REPORT ON

**A171 WHITBY PARK AND RIDE FACILITY:
ADDENDUM TO ENVIRONMENTAL STATEMENT
JUNE 2007**

08514580139.501/A.0

Document Title A171 Whitby Park & Ride Facility:
Addendum to ES June 2007

FIGURE 5 REV A: VISUAL ANALYSIS

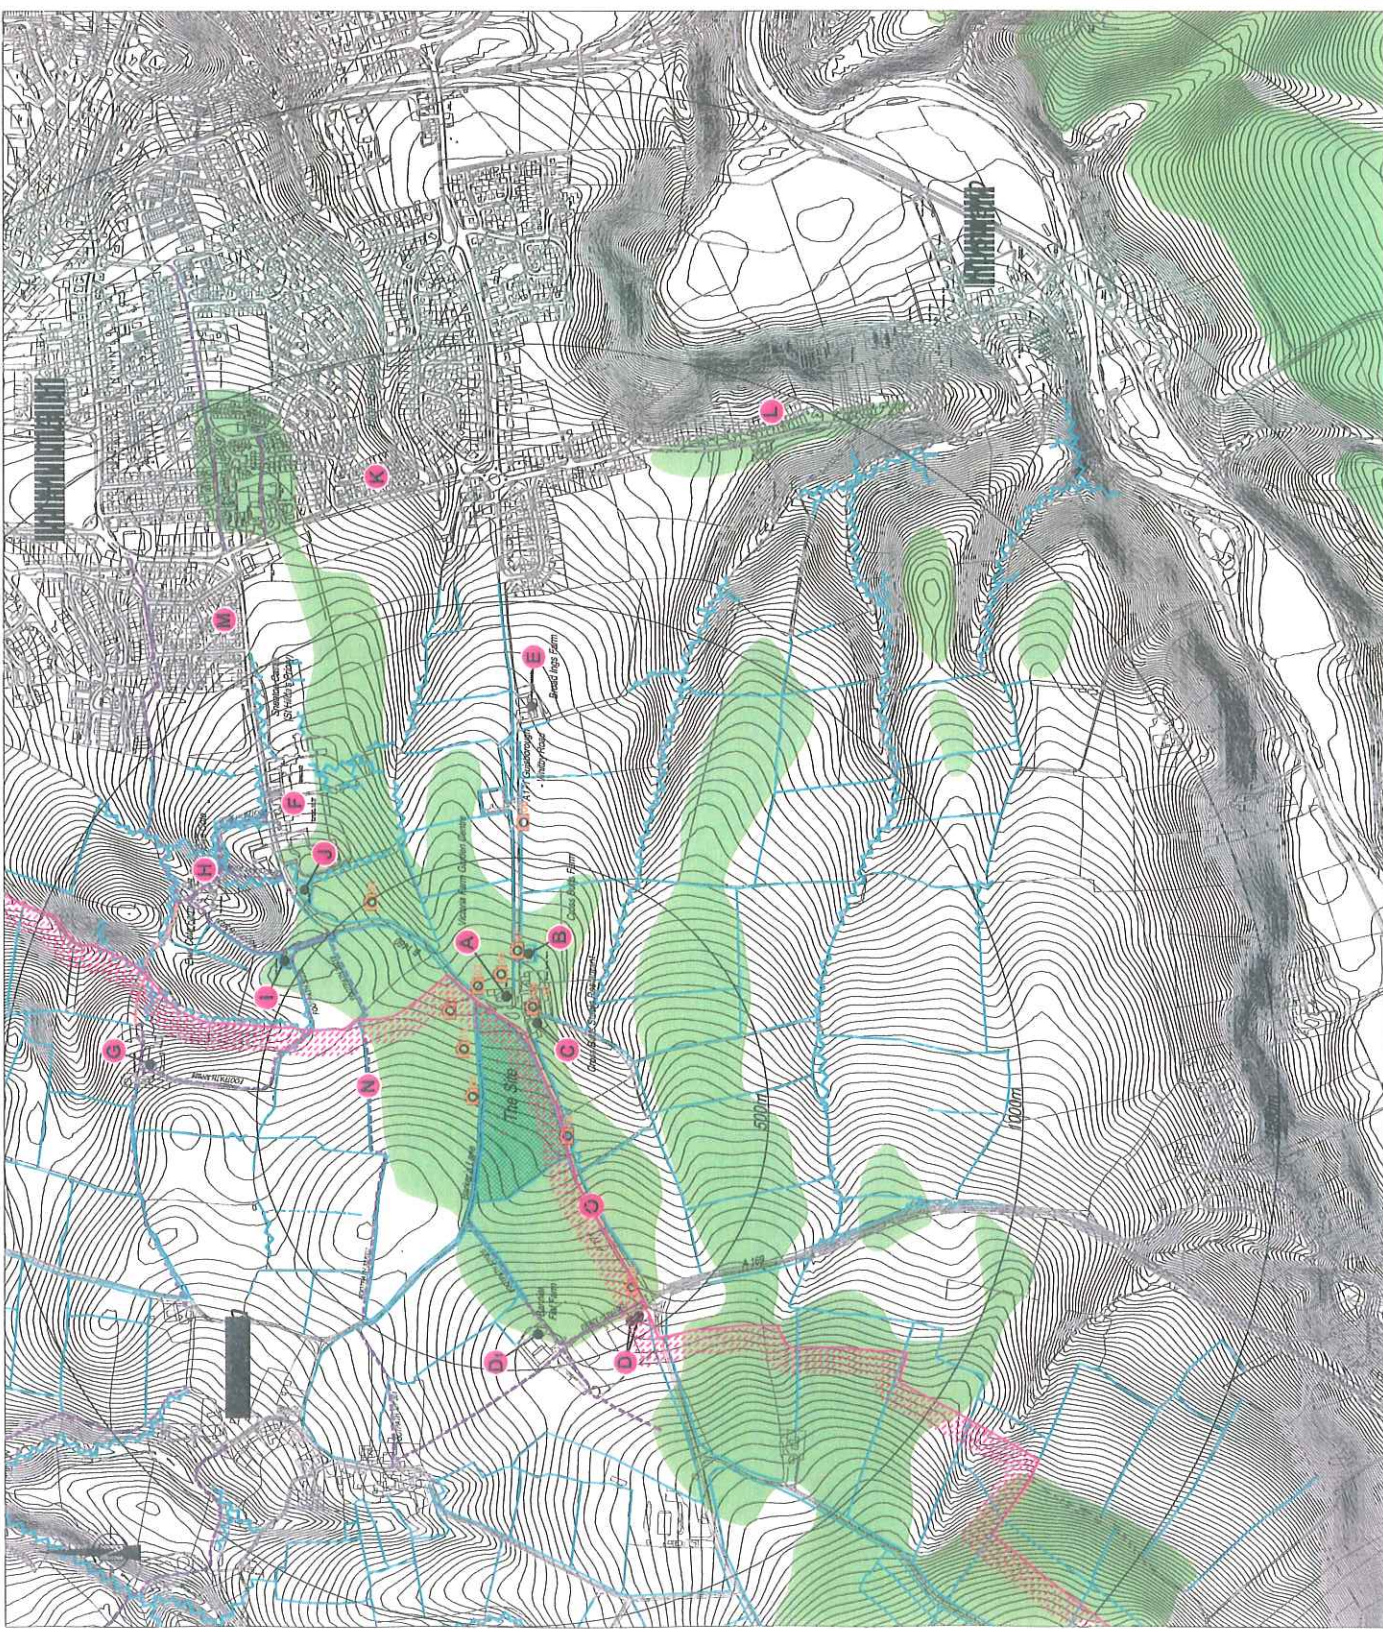
Page 54: Section 5.10 Assessment of Visual Impact – Paragraph 2 and Paragraph 4 states: *“Figure 5 shows the approximate visual envelope for the scheme and was generated by superimposing the 3D digital proposals onto a digital terrain model for the region. The dark green hatch shows the areas from which the parking facility would be visible (assuming no mitigation is implemented) the light green hatch shows the area from which the 6 m high lighting columns would be visible”.*

“As expected the ZVI for the lighting columns is considerably greater than the car park (which is partly cut into the hillside, and therefore partially screened). However in both cases the visual envelopes are restricted by the undulating topography to localised areas of high ground to the south and east, which are mostly open farm land”.

Refer to the amended Figure 5 Visual Analysis Plan (Appendix 1). This shows the Zone of Visual Influence (ZVI) for the proposed parking facility only (shown in dark green). The ZVI for the lighting columns (previously shown in light green) has now been removed.

Rev	Description	Chd.	Appd.	Date
A	Lighting ZVI removed due to lighting removed from scheme	NR	NR	03.08.08

Figure 6.1

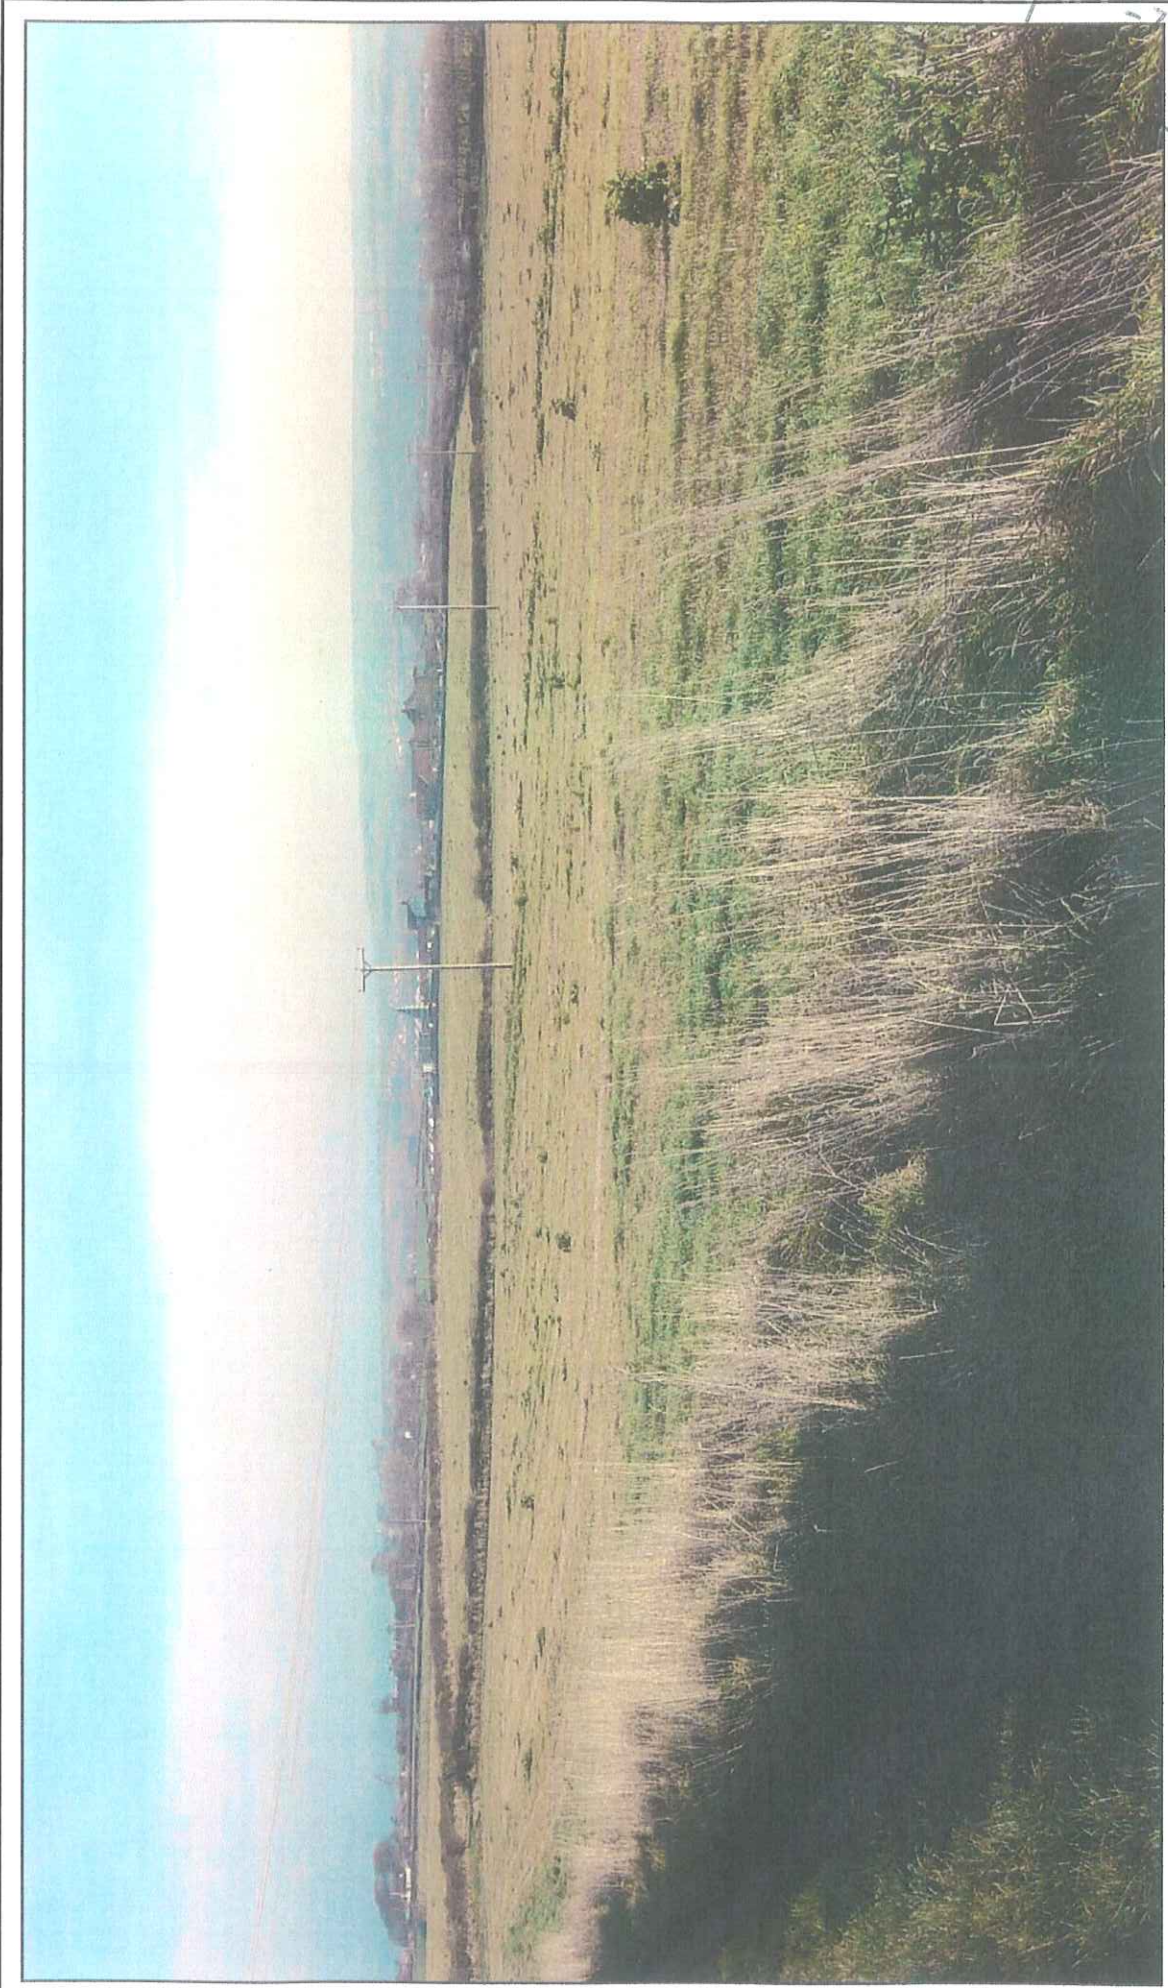
Page 55: Section 5.10 Assessment of Visual Impact – Paragraph 5 states: “*To aid visual assessment of the proposals photomontages have been prepared for three separate viewpoints (refer Figures 6.1-8.3). The montages have been generated from 3D wireframe CAD models, which have been ‘camera matched’ to site photographs and digitally rendered using appropriate software to create realistic textures and colours*”.

- *The lighting columns are comparatively intrusive”.*

Refer to Appendix 2 for the revised Photomontage Figures 6.1-8.3. These have been amended to reflect the scheme on completion and at 15 years with the internal lighting columns omitted.
